Memorandum

Re: Sugar Town/Snelgrove Ice Cream Factory – Design Review Work Session

Petition PLNPCM2021-oo025

DESIGN REVIEW – WORK SESSION

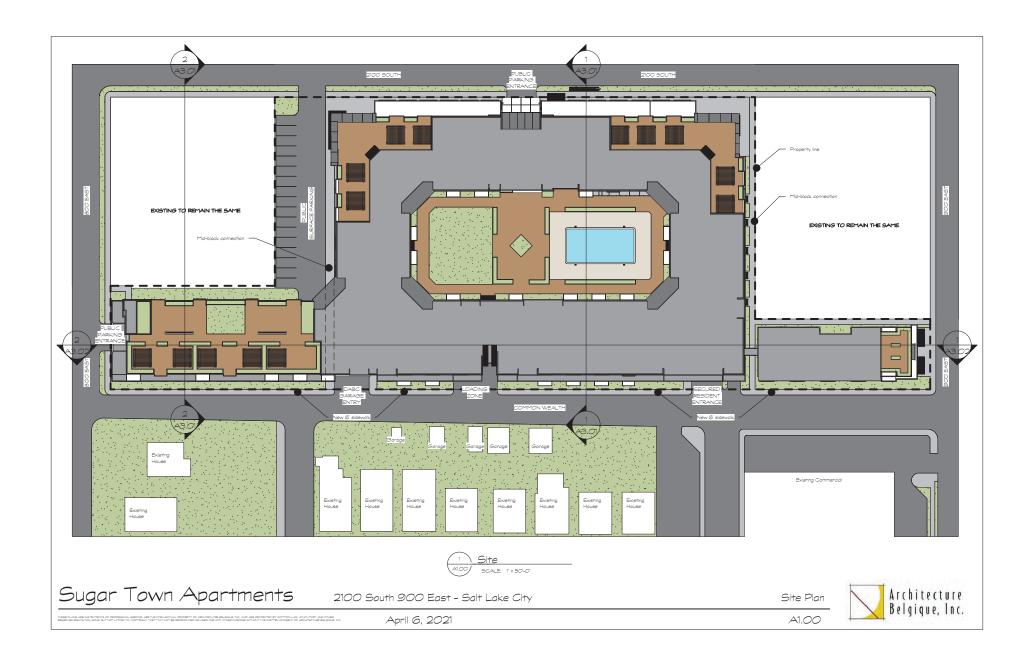
When looking at the north façade (2100 South) and associated floor plan, a proposed DABC State Liquor Store constitutes a substantial space (approximately 148') along this façade, and is located next to a 35' parking garage entrance which interrupts the façade in the middle of the building. This parking garage entrance is not pedestrian friendly and would only seem to cause pedestrian conflict as opposed to interest. The eastern portion of this façade is comprised of a very large residential leasing office and a fitness center of similar size. Planning Staff questions why the leasing office area, that would hold little to no interest to the public, would need to be so large and comprise such a large length of the street level façade. It seems like this is a missed opportunity for some retail or commercial space. With the exception of the liquor store, there is no space for commercial use along this stretch of 2100 South, which serves as a commercial corridor for the neighborhood, and therefore very little in terms of pedestrian interest. Planning Staff notes that there are only two building entrances proposed over this long length of street front (365'). The entrance to the liquor store is located on the eastern façade.

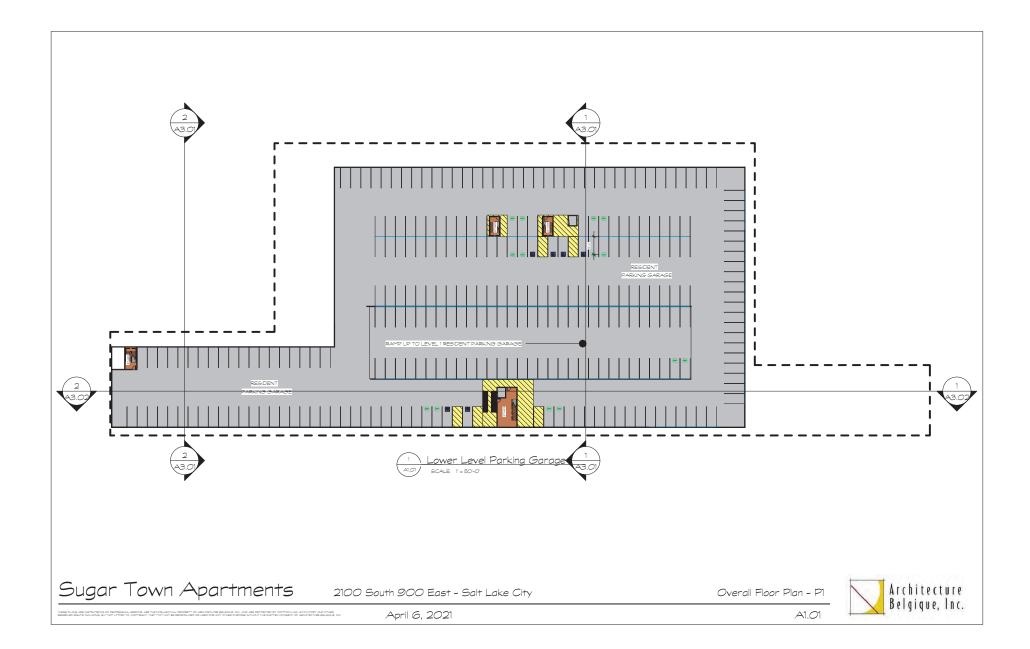
The south elevation (Commonwealth Avenue) at the street level on the western end, is composed of approximately 185' of enclosed ground level parking garage with windows at regular intervals. Planning Staff notes that the code requires active uses at the ground level at the street in the CSHBD zone and further states that parking should be located behind said active ground level uses. Could this large stretch of façade not be residential units similar to what is proposed toward the middle of this façade, effectively masking the parking? The middle portion of the façade shows six residential units that front the public street, which is positive, but there is no design detail provided indicating how these units interact with the sidewalk. The remaining eastern portion of this façade is more windows. This east portion, according to the floor plan consists of residential units, but there is no indication that these units have direct street access thereby providing activity and pedestrian interest. From the elevations and floor plans it seems like these units would be accessed internally via a hallway. Planning Staff notes that the street front ground level use along Commonwealth Avenue could benefit from more residential use to help transition into the residential neighborhood adjacent to the south.

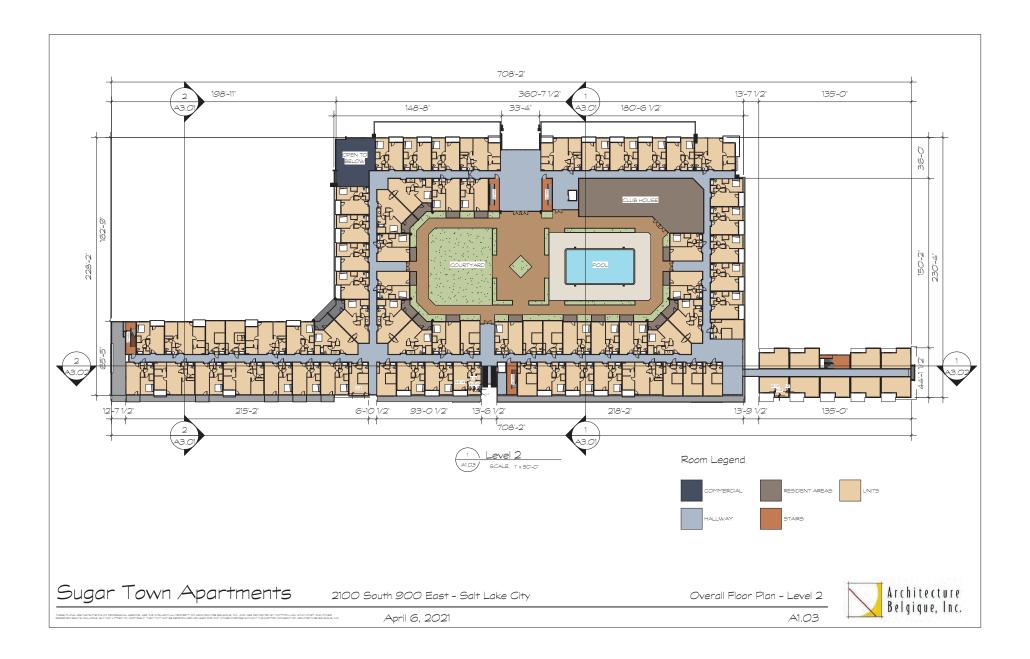
The east elevation at the street is labeled "Art Space" and appears to be retail or commercial in nature. The façade is transparent but there is no description of what this space will be used for and how it will enhance the pedestrian experience. Planning Staff notes that there is a bus stop directly in front of this façade.

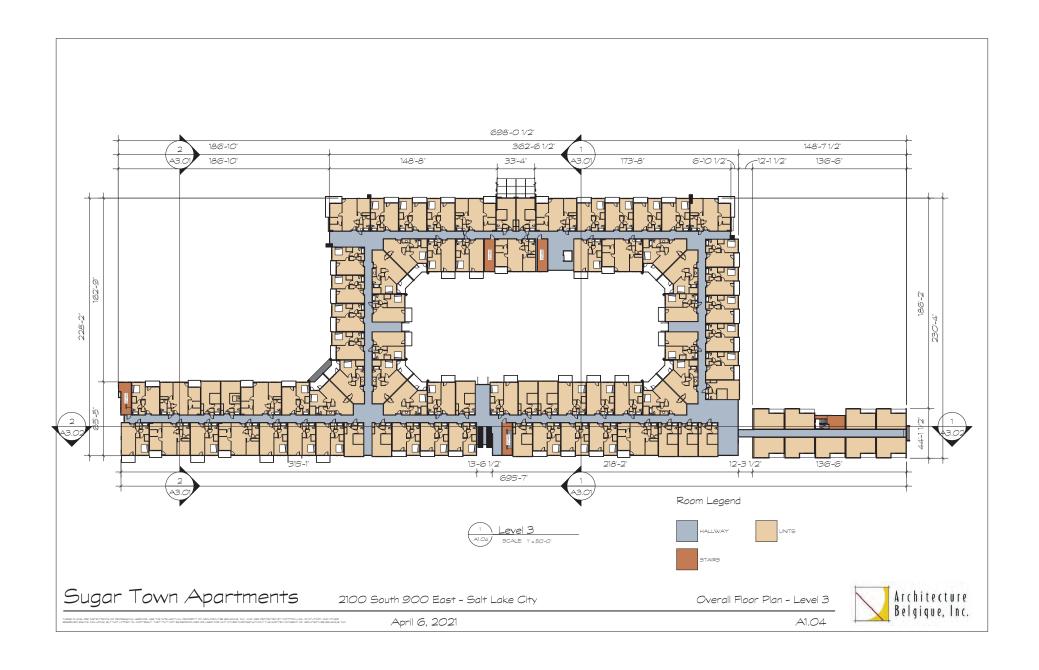
The west elevation is essentially the public parking entrance to enclosed ground level parking.
